H.B.ROBINSON STEAM ELECTRIC PLANT, UNIT NO. 2
NRC DOCKET NO. 50-261/LICENSE NO. DPR-23
REQUEST FOR LICENSE AMENDMENT

PAGE CHANGE INSTRUCTIONS

H. B. ROBINSON STEAM ELECTRIC PLANT, UNIT NO. 2
NRC DOCKET NO. 50-261/LICENSE NO. DPR-23
REQUEST FOR LICENSE AMENDMENT

TECHNICAL SPECIFICATION PAGES

FIGURE
3.1-1.2

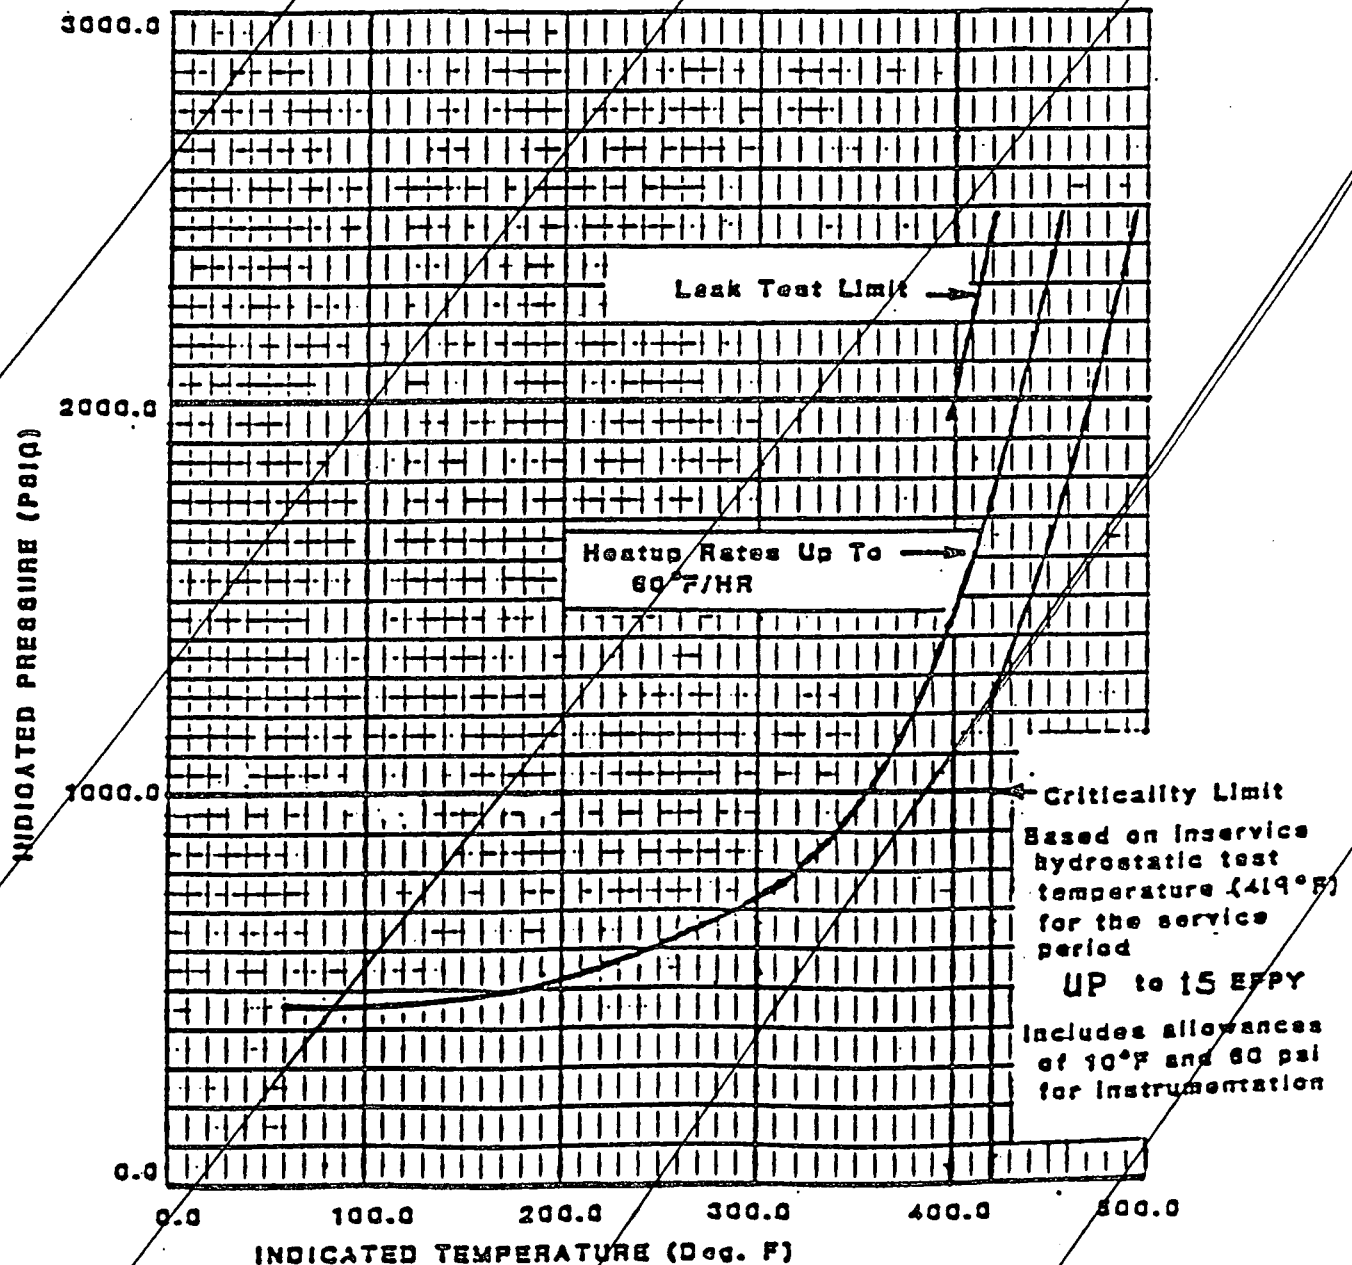
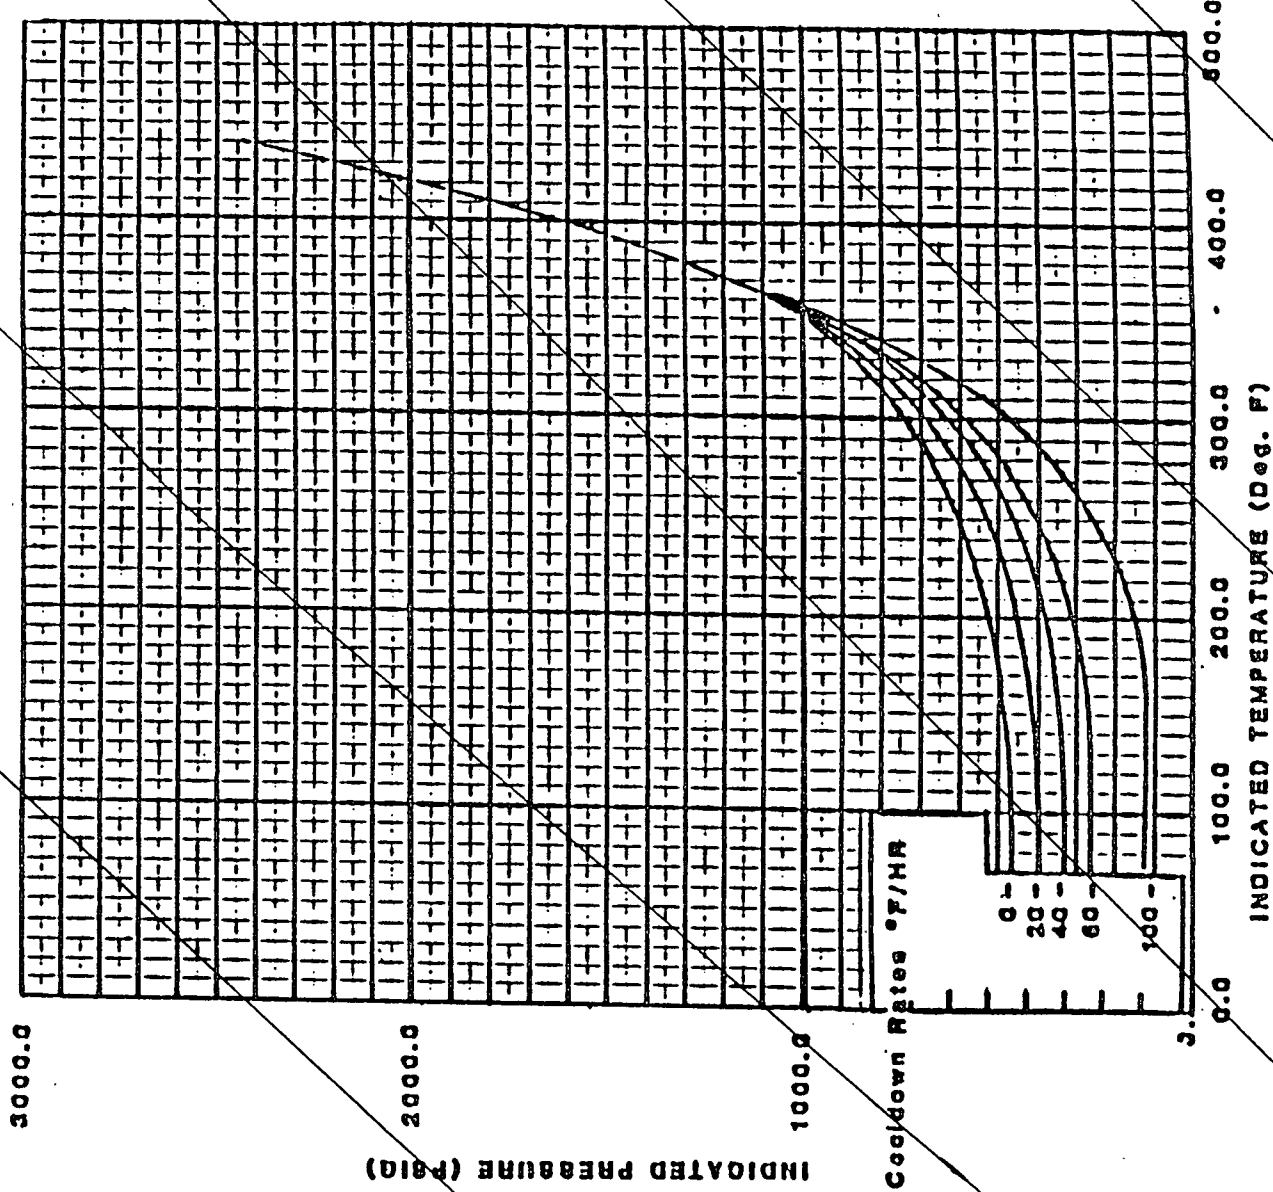
Reactor Coolant System
Heatup Limitations - Applicable
Up To 12.5 EFPY

THIS FIGURE DELETED

Reactor Coolant System
Heatup Limitations - Applicable
Up To 15 EFPY

3.1-2.a

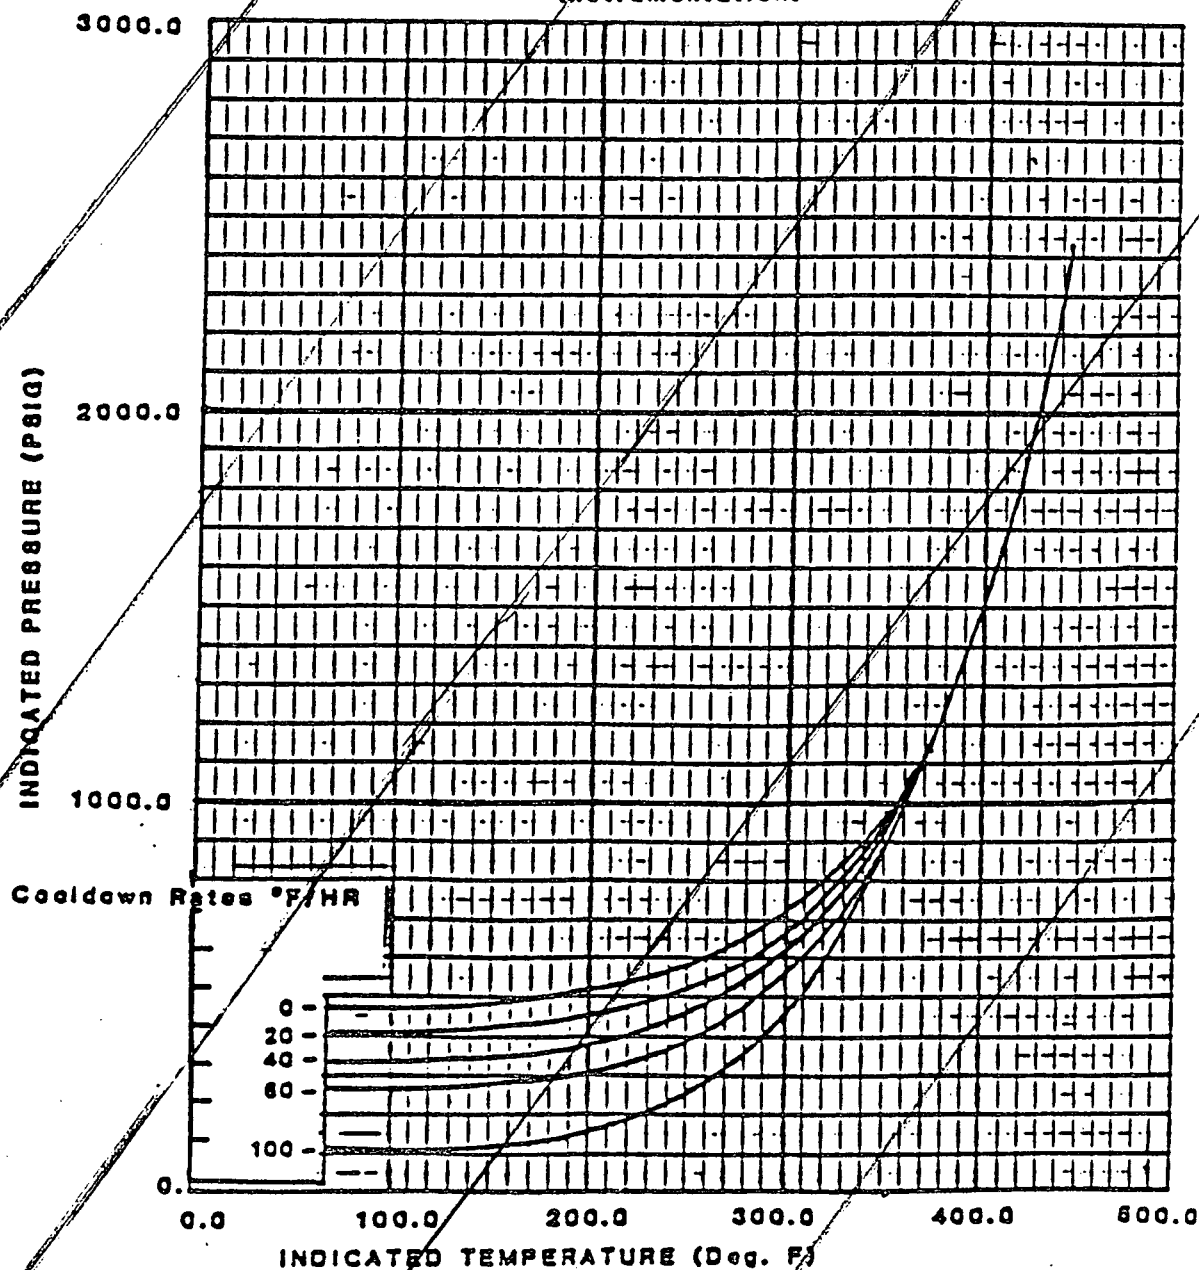
Reactor Coolant System
 Cooldown Limitations
 Applicable Up To 12.5 EFY

THIS FIGURE
DELETED.

3.1-1

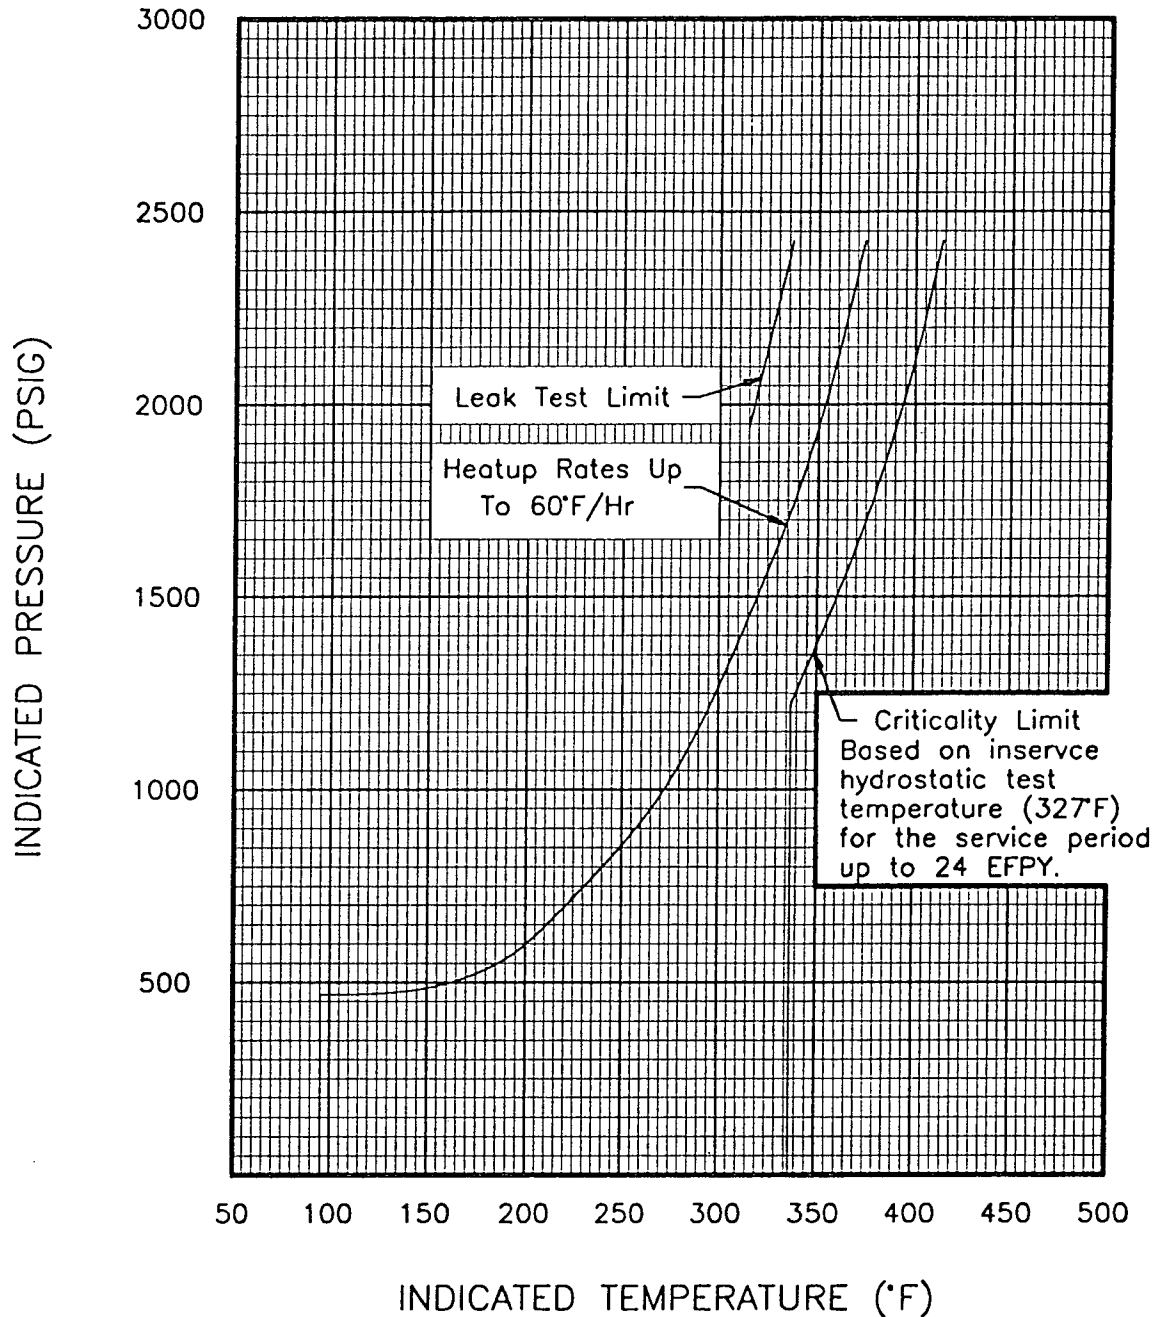
The reactor coolant pressure and the system heatup and cooldown rates (with the exception of the pressurizer) shall be limited in accordance with Figure 3.1-1 and Figure 3.1-2 (for vessel exposure up to 24 EFPY). These limitations are as follows:

- c. Primary system hydrostatic leak tests may be performed as necessary, provided the temperature limitation as noted on Figure 3.1-1 is not violated. Maximum hydrostatic test pressure should remain below 2350 psia.

Controlling Material : Lower Circumferential Weld
 Copper Content : 0.20 wt.%
 Nickel Content : 1.06 wt.%
 RT_{NDT} Initial : -80°F
 RT_{NDT} After 24 EFPY : 1/4 T. 207.83°F
 3/4 T. 137.15°F

Curves applicable for heatup rates up to 60°F/Hr for the service period up to 24 EFPY.

Includes +10°F and -60 PSIG allowance for instrumentation error.

3.1-2

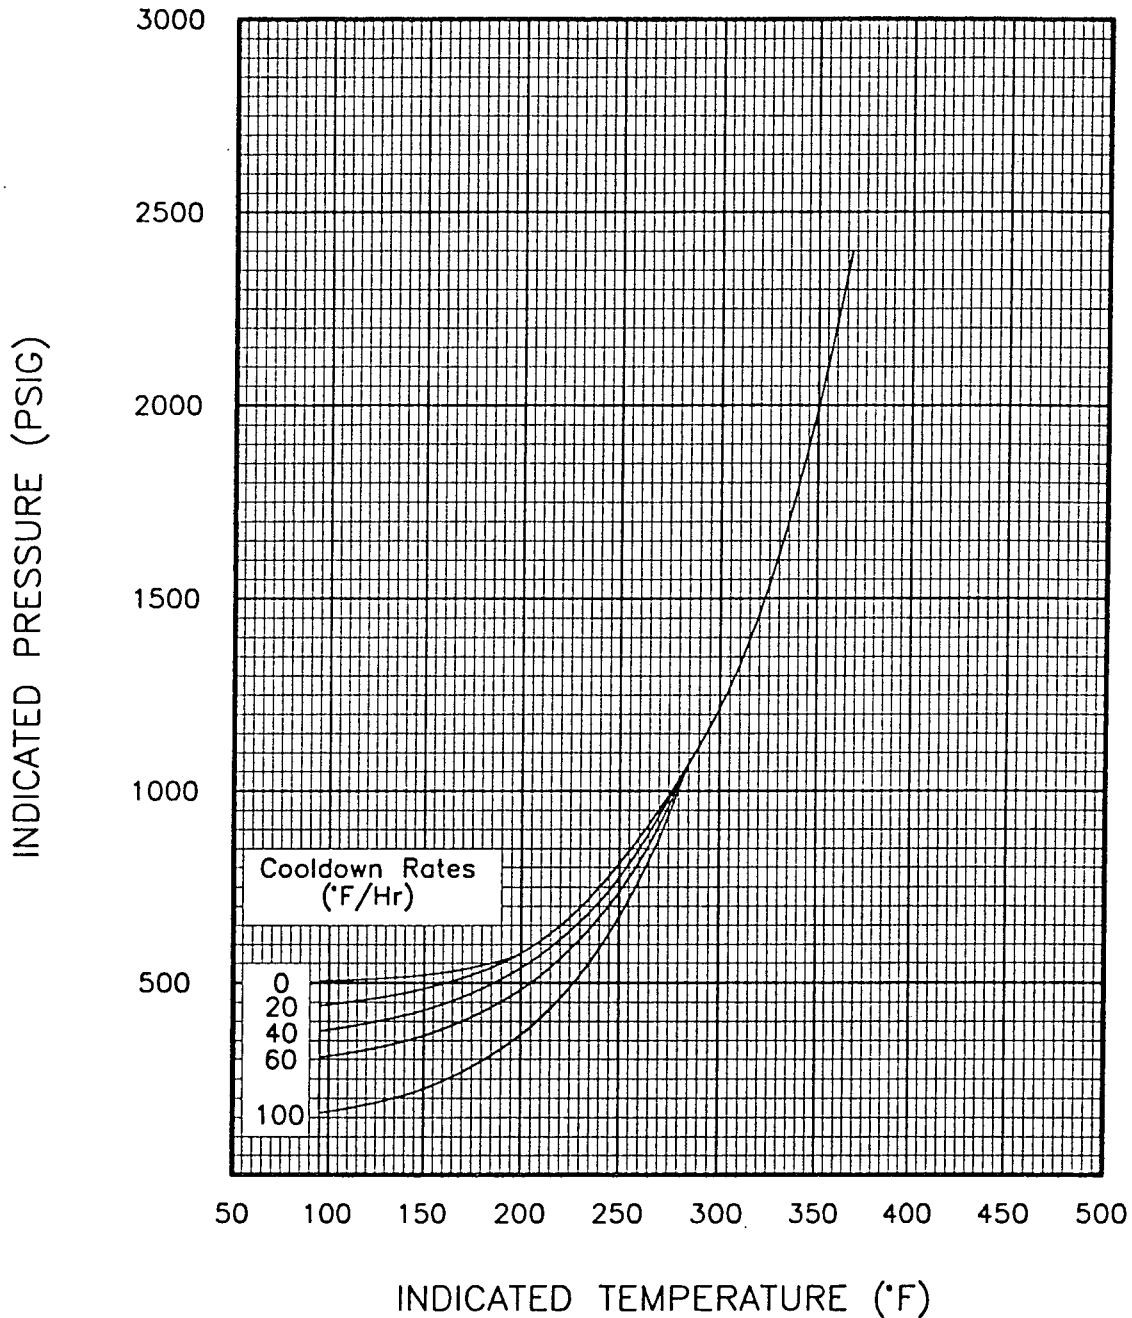
- a. Over the temperature range from cold shutdown to hot operating conditions, the heatup rate shall not exceed 60°F/hr. in any one hour.
- b. Allowable combinations of pressure and temperature for a specific cooldown rate are below and to the right of the limit lines for that rate as shown on Figure 3.1-2. This rate shall not exceed 100°F/hr. in any one hour. The limit lines for cooling rates between those shown in Figure 3.1-2 may be obtained by interpolation.

Controlling Material : Lower Circumferential Weld
 Copper Content : 0.20 wt. %
 Nickel Content : 1.06 wt. %
 RT_{NDT} Initial : -80°F

RT_{NDT} After 24 EFPY : 1/4 T. 207.83°F
 3/4 T. 137.15°F

Curves applicable for cooldown rates up to 100°F/Hr for the service period up to 24 EFPY.

Includes +10°F and -60 PSIG allowance for instrumentation error.
